C13  
1**ZONING CHANGE REVIEW SHEET**

**CASE:** C814-2012-0160  
211 South Lamar PUD

**ADDRESS:** 211 South Lamar Boulevard

**ZONING TO:** PUD; Planned Unit Development

LAND USE PLAN

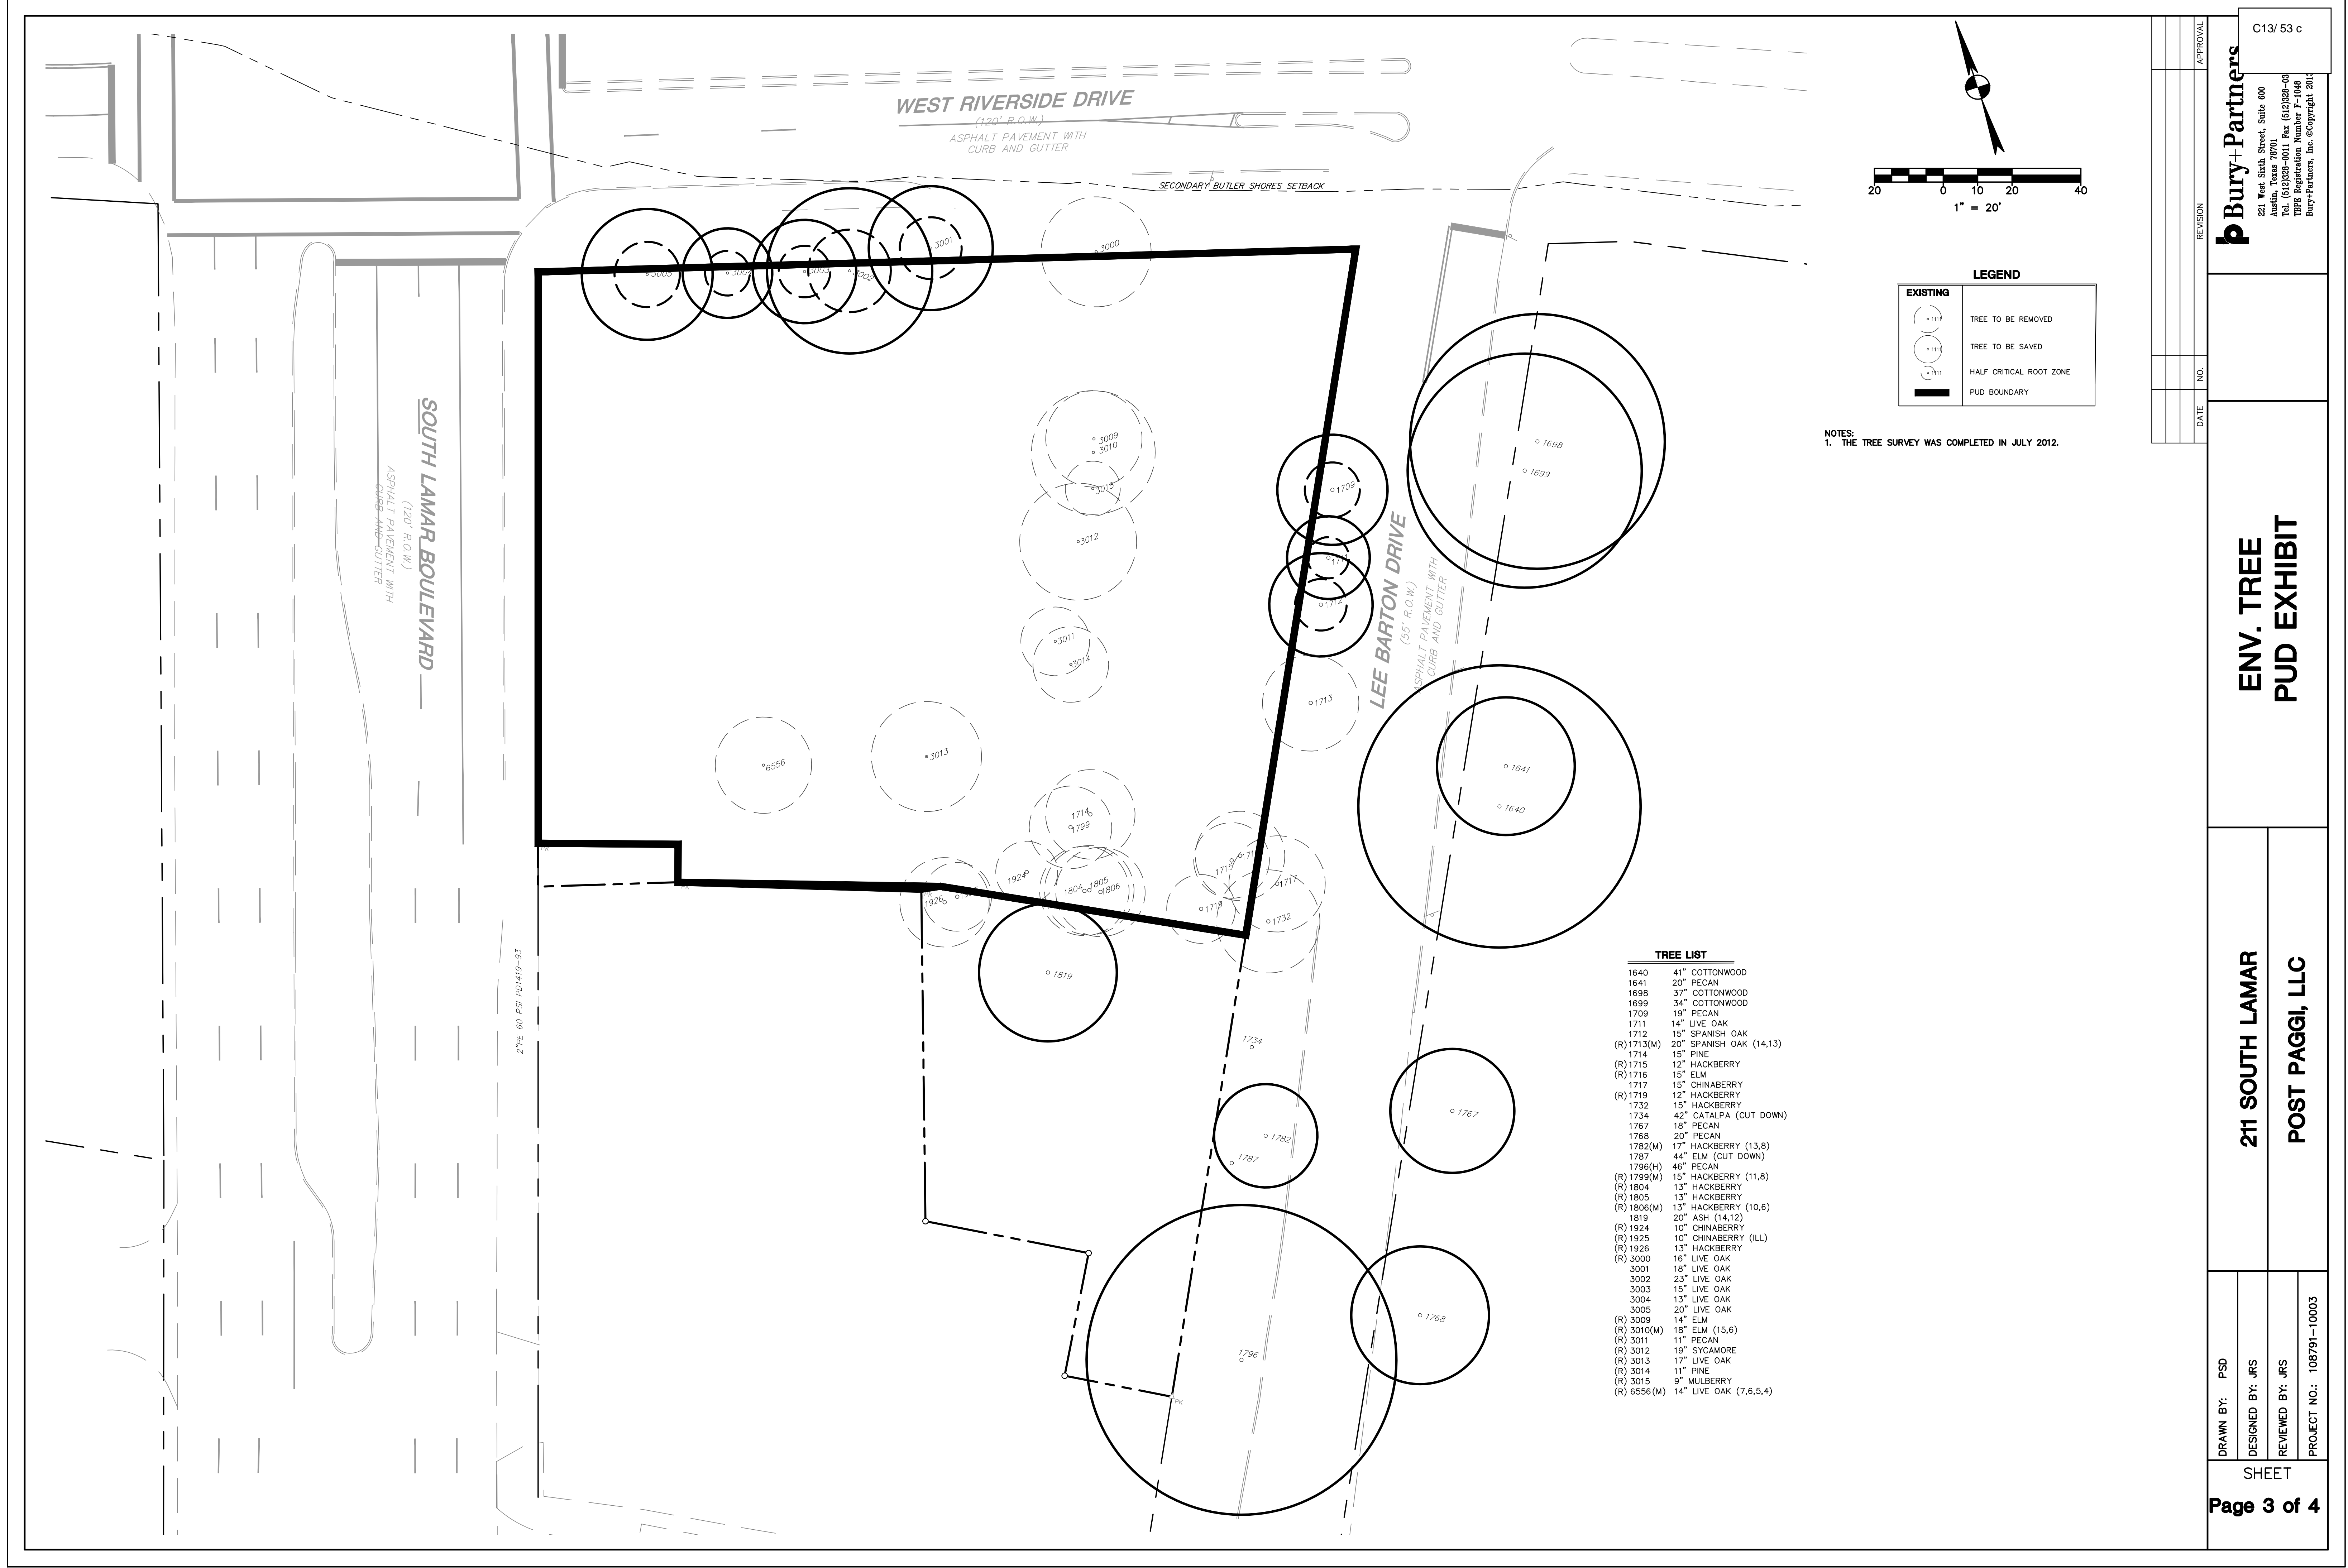
- h. Note # 32: Please highlight trees in Sheet 1 schematics. See also 6a, below.
- i. Note # 33/Variance to TCM9.3.0 #3: Is this a variance to zoning requirements or to site-planning requirements? If it is appropriate to consider at the rezoning stage, then provide the documentation from Transportation (see reviewer note #7) concurring with the proposal. If this is NOT a variance to the zoning code, but associated with site-planning, then please remove from plan sheet and table of CS variances.

- 3. Land Use Plan Comments – Sheet 1**
- a. Please clearly distinguish existing versus proposed land use; separate schematics on the same sheet would be ideal. Clearly depict PUD boundary (heavier line) and future building lines. What's the buildable area? Is there a setback from the Bridges building? Please label Paggi House and Bridges buildings as existing. Identify Fast Food Restaurant as Existing.

- i. The Land Use Plan has been revised to remove color depictions and is now black-and-white.**
4. Land Use Plan Comments – Sheet 2
- a. As noted above, please be consistent with items noted in the Tier Tables. If something is specified, quantified, qualified, or otherwise elaborated upon in one, please do so in the other. Note: Some of these plan notes may be incorporated into the PUD document instead of, or in addition to, being on the plan sheet. Specificity matters.

- g. **Noted.**
- h. Note # 32: Please highlight trees in Sheet 1 schematics. See also 6a, below.
- h. **A new sheet has been added to the Land Use Plan clarifying tree preservation.**

ENV. TREE  
PUD EXHIBIT

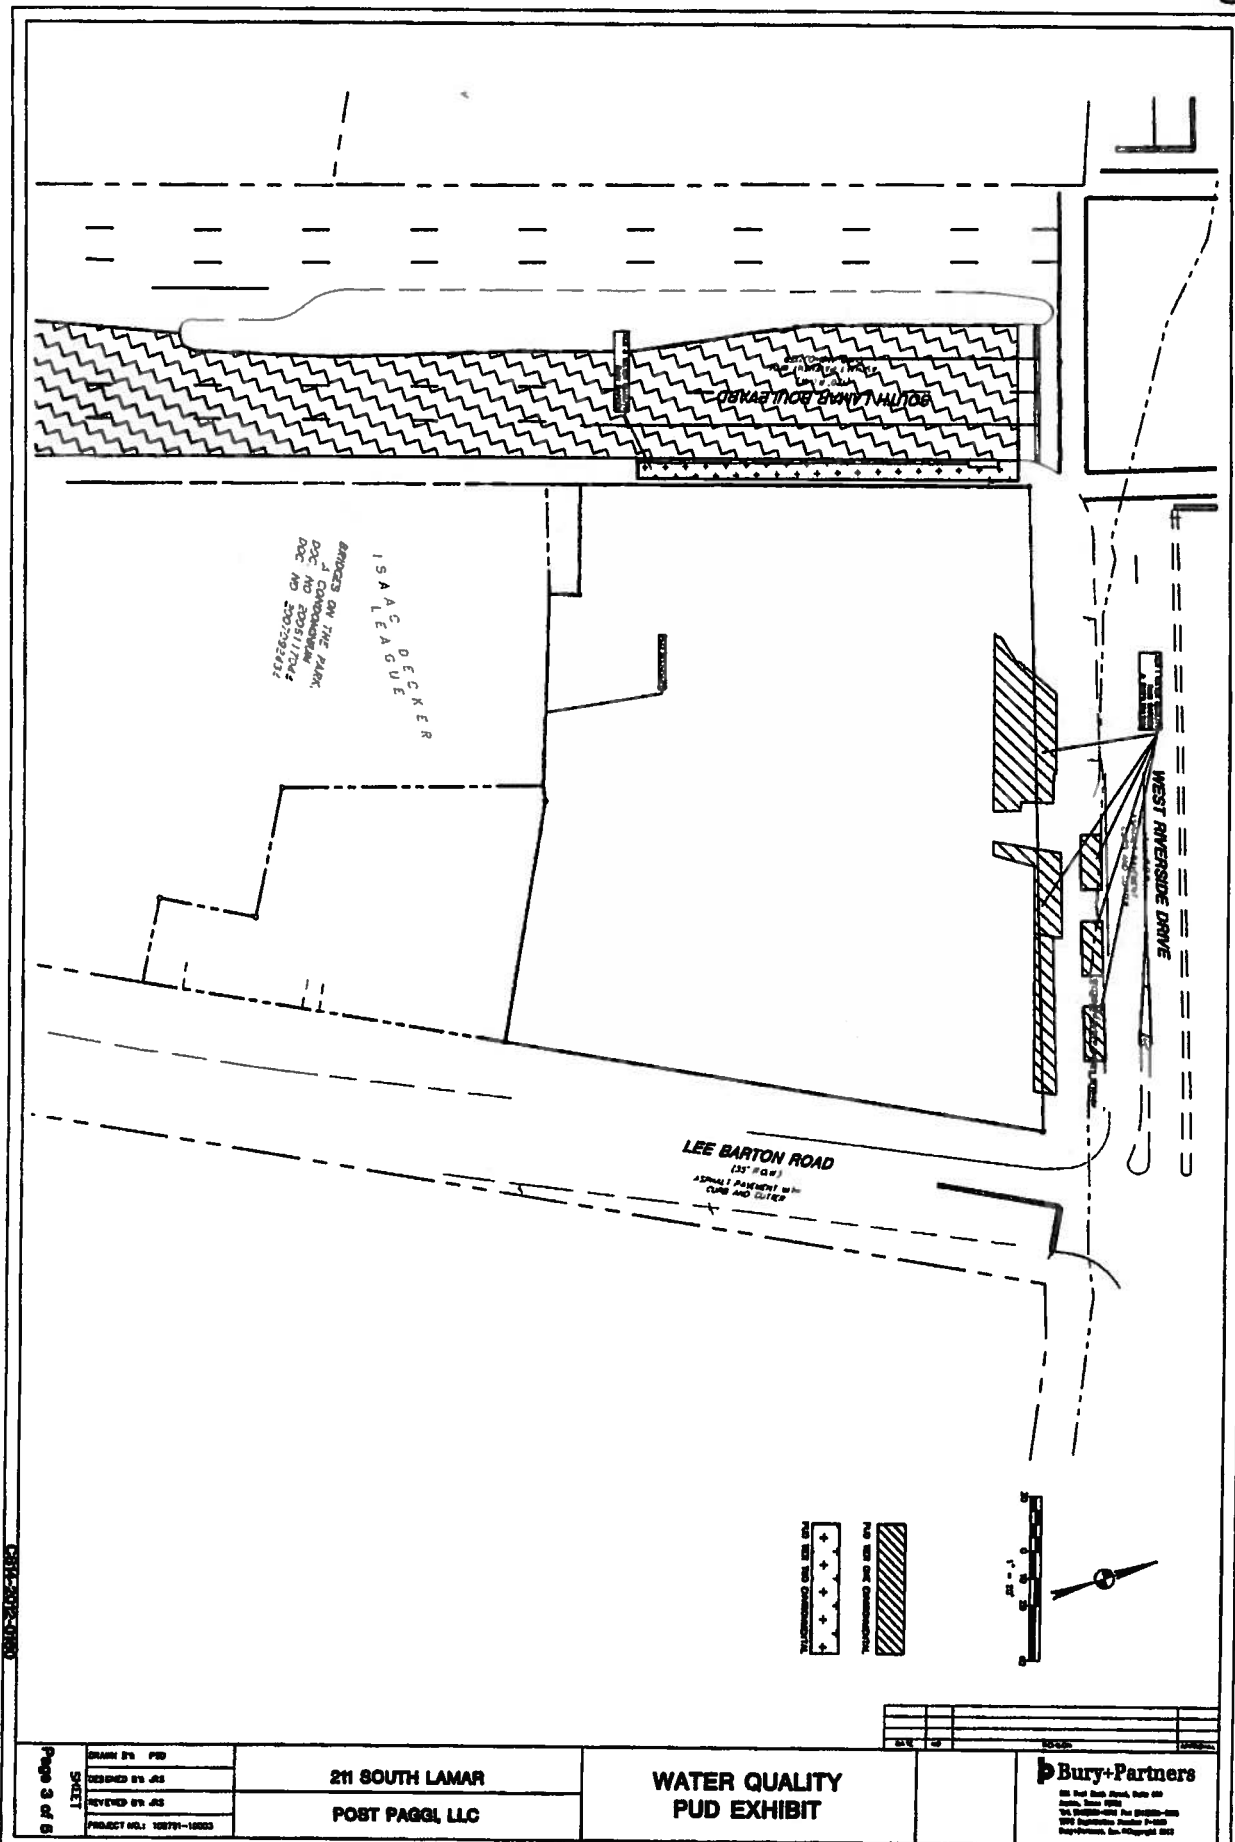
**UPDATE #1 Note # 32 addresses the tree preservation criteria required to preserve trees in the PUD. The Env. Tree PUD Exhibit, sheet 4, shows tree #1709 to be removed in the list when it is supposed to remain, and it shows tree 1732 with a 50 ft CRZ instead of a 30 ft CRZ as stated in the tree survey list. Please correct these inconsistencies. This comment can be cleared informally.**
